**MODIFICATION REQUEST:
Bennelong Parkway, Homebush Bay
(MP09_0160 MOD 2)**

***Increased height, density and car parking for
approved residential development concept plan.***

Director-General's
Environmental Assessment Report
Section 75W of the
Environmental Planning and Assessment Act 1979

July 2013

Figure 3: Proposed modified heights in storeys (with approved heights in brackets)

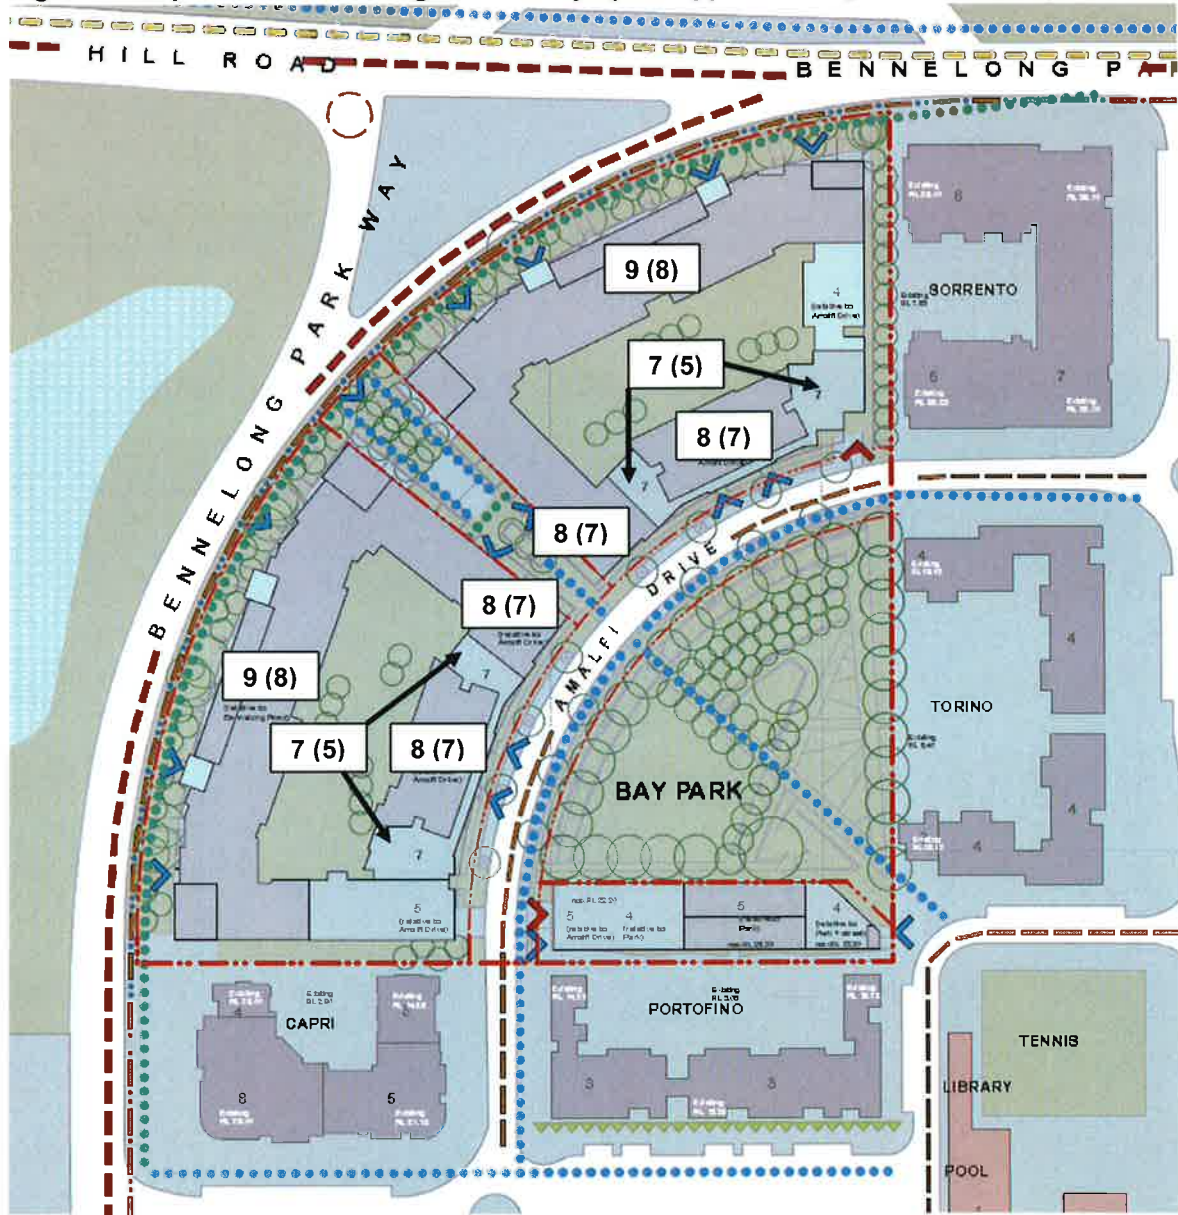
It is proposed to increase the height of Buildings B and C (refer to **Figure 3**) as follows:

- Eight storey components to increase to nine storeys;
- Seven storey components to increase to eight storeys; and
- Five storey infills to increase to seven storeys.

The Department's assessment of the Concept Plan generally supported the development and considered the building envelopes were an appropriate fit within the context of surrounding development, subject to a reduction in the height of the south eastern corner of Building B, facing Amalfi Drive, to five storeys. This was to ensure the development would be compatible with the height and scale of existing and adjoining buildings (refer to **Figure 3**).

The PAC, in determining the Concept Plan, considered the Department's recommended amendments, and recommended the application be approved, subject to the envelope of the south eastern corner of Building B being reduced to a maximum of five storeys (RL 22.35) by deleting the proposed eight units on levels five and six. The proposed modification complies with the amendments made as part of the PAC determination as it does not change the approved five storey height of the south eastern corner of Building B facing Amalfi Drive.

The proposed modification complies with the DCP height limits except for the nine storey component which exceeds the height limit by one storey.

The nine storey component is located on the south-western edge of the site adjacent to the wide setback provided by the carriageways of Bennelong Parkway and Hill Road. This siting means there will be no unreasonable impacts on the development itself or adjoining residential flat buildings. Furthermore, the nine storey component will not result in any additional mid winter overshadowing of the neighbouring building to the south east or result in any unreasonable impacts on existing views and outlook from adjoining properties.

The Department considers that the nine storey component is reasonable and consistent with DCP's height objectives, as the proposal:

Notwithstanding, the Department's support for the nine storey component, it recommends an additional future assessment requirement demonstrating high architectural quality to break the overall mass of the building into smaller elements and the use of a variety of textures, materials and colours. This will assist to further articulate the building surface, reduce the building's visual scale and improve its appearance from the street. This requirement (see below) is included in the recommended modification instrument.

Future Development Applications shall demonstrate high architectural quality breaking the overall mass of the building down into smaller building elements and through the use of a variety of textures, materials and colours to articulate the surface and reduce the visual scale of the nine storey component of Building B and improve its appearance from the street. This can include:

Figure 7: Outlook from neighbouring Capri building in relation to proposed nine storey component

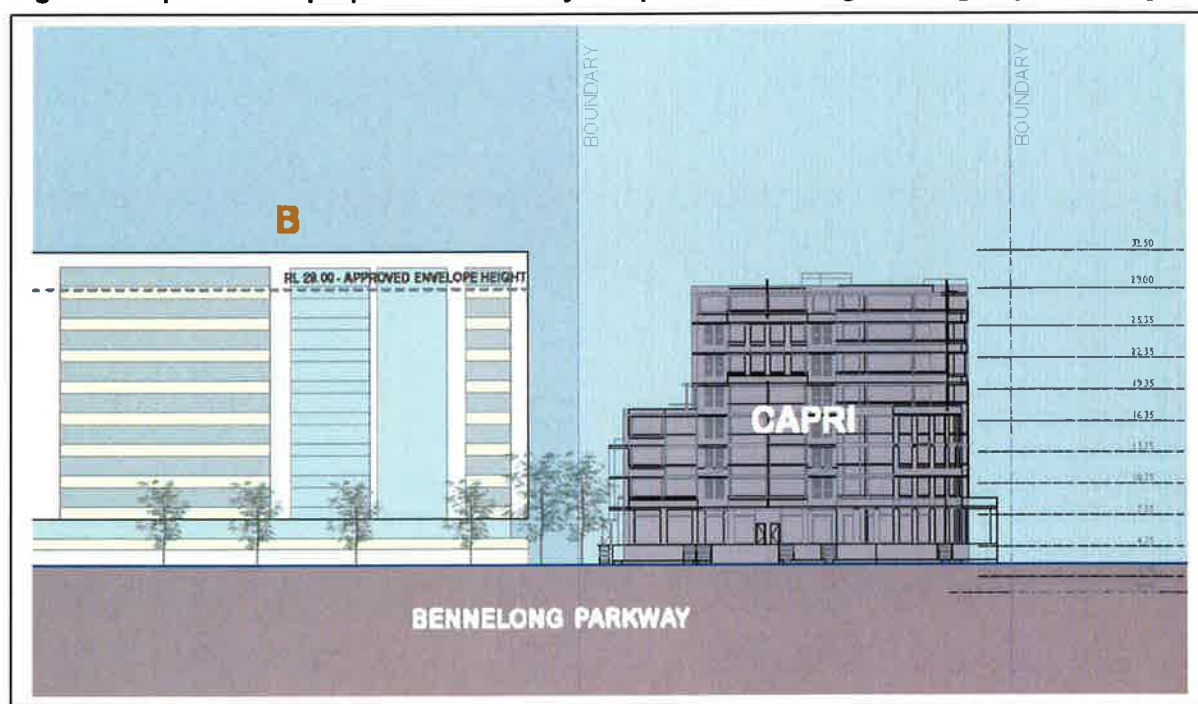
The proposed additional storey to Building B will not cause any additional mid winter overshadowing of the neighbouring Capri building to the south east (**Figure 5**) and will maintain existing views and outlook (**Figures 6 and 7**). The proposed modification would achieve compliance with the Residential Flat Design Code rule of thumb for 70% of dwellings to receive at least three hours of sunlight between 9 am and 3 pm at mid winter.

Figure 8: Views identified in Homebush Bay West DCP 2004

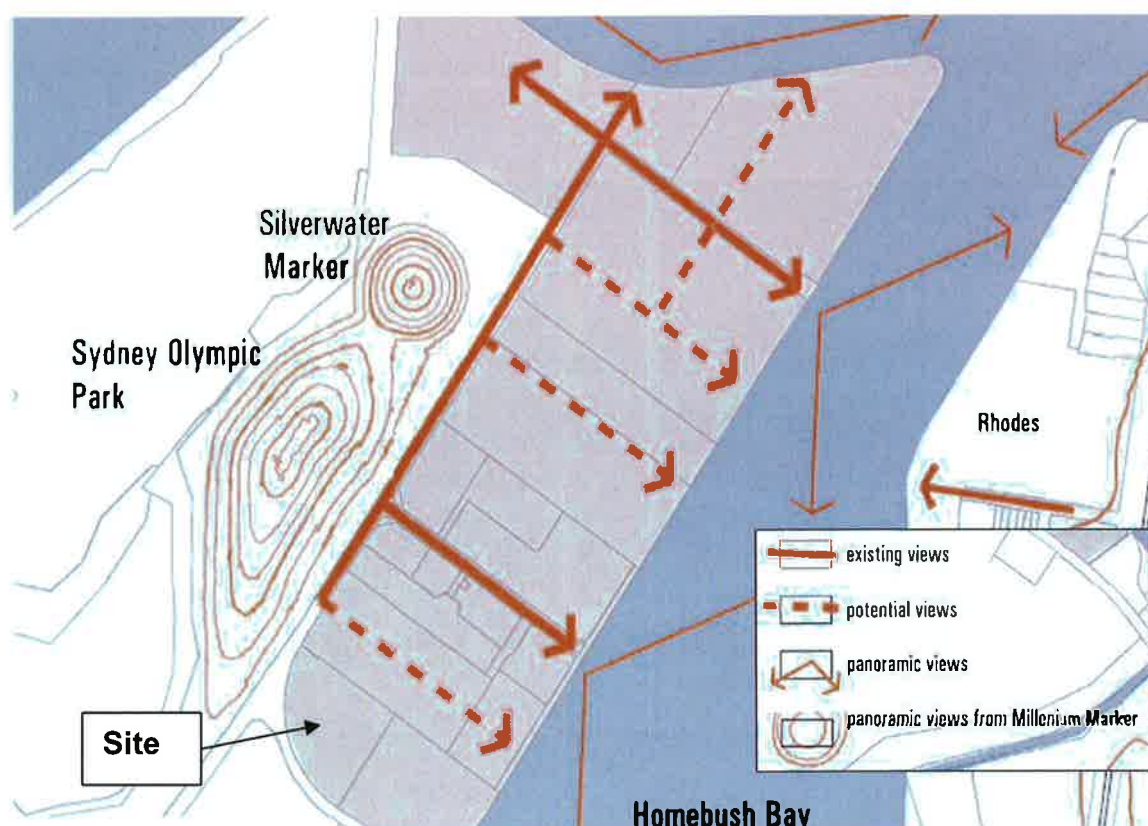
The DCP identifies views of value within Wentworth Point generally to the water and surrounding hills and along north-south and east-west corridors created by the new street network within Precinct F (see **Figure 8**). The site is located on the south western corner of the precinct, and the development as proposed to be modified will not result in any adverse impacts on the identified views.
